ADDENDUM NO.: THREE DATE: 10 APRIL 2017

PROJECT TITLE: **REBID: NUTRITION STATION DODIE
ANDERSON ACADEMIC ENRICHMENT CENTER**
University of South Carolina
Columbia, South Carolina

PROJECT NO.: H27-Z302 WTS No. 1627

1
E0.01
SCALE: NOT TO SCALE

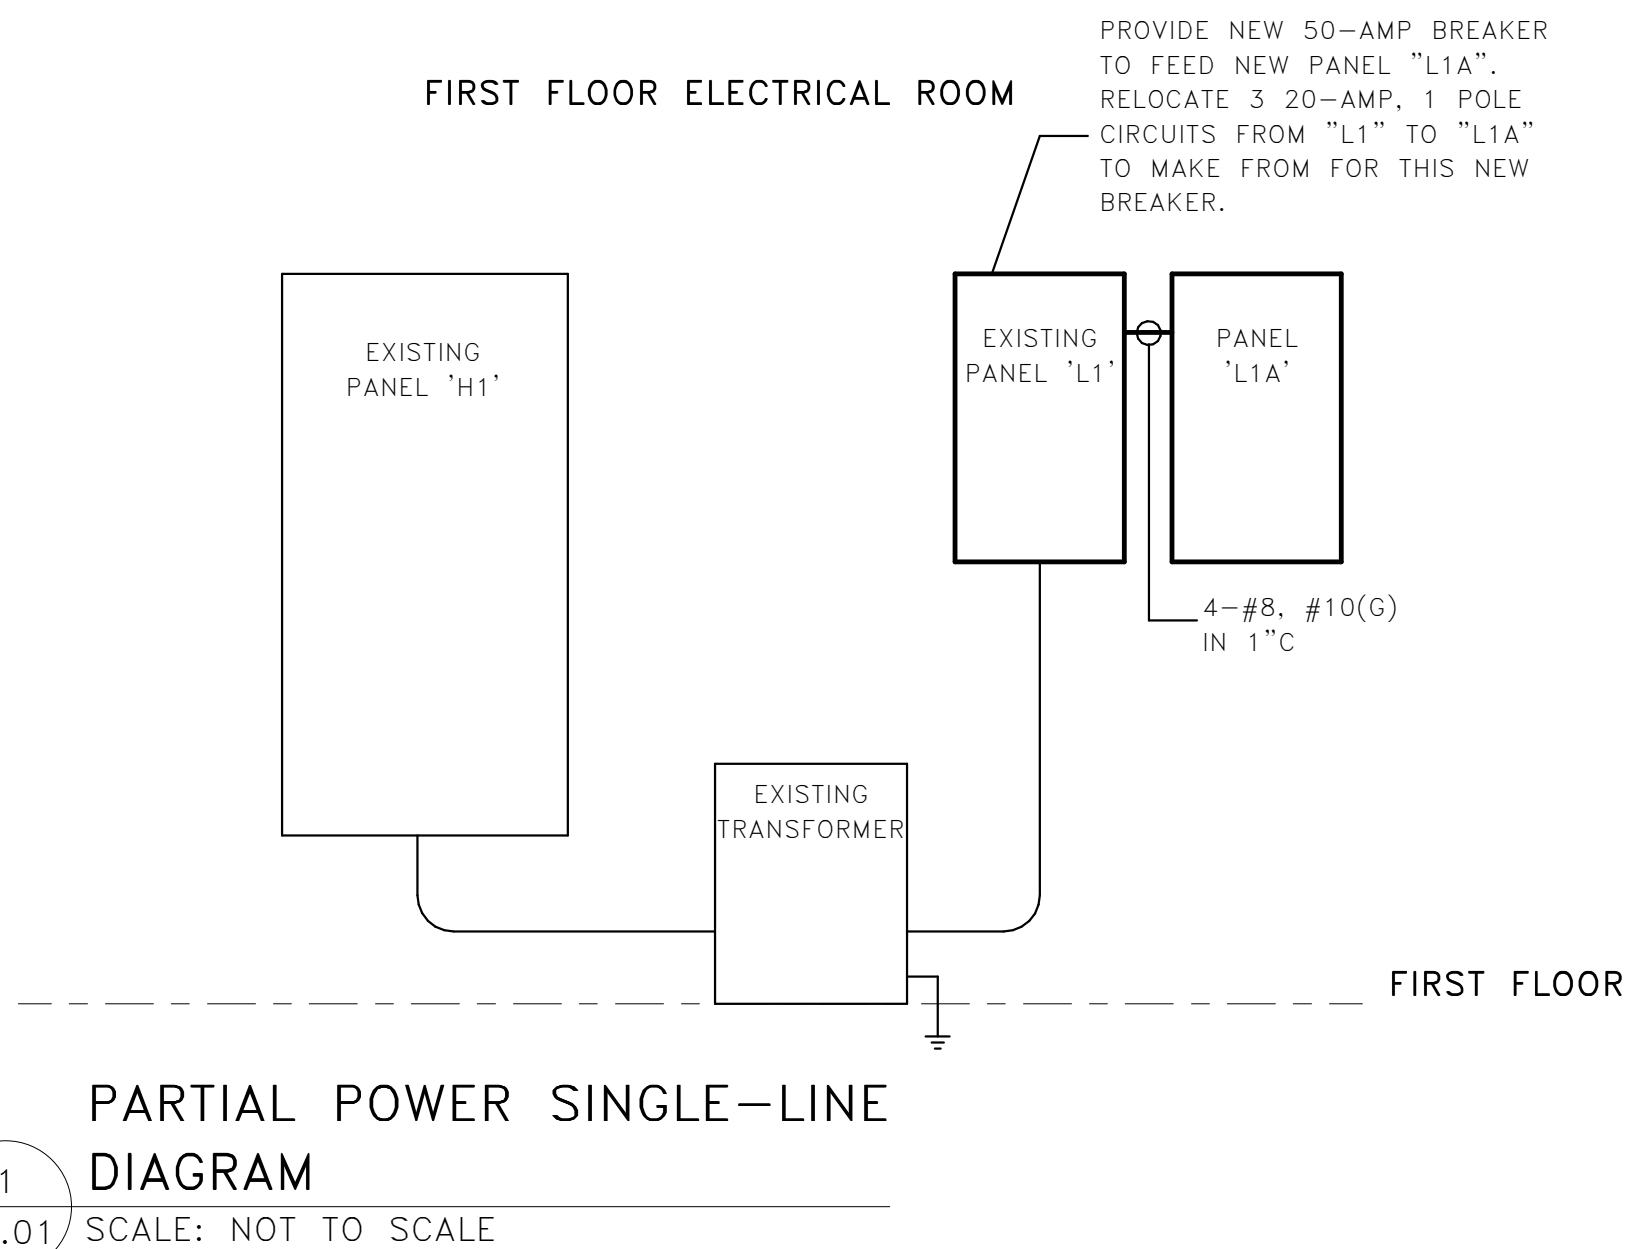
1. E0.01 ELECTRICAL NOTES AND LEGENDS:
 - a. As shown on the attached Sheet E0.01, Panelboard Schedule for "L1A", change main ratings to 100-amps and change main breaker to main lugs only.
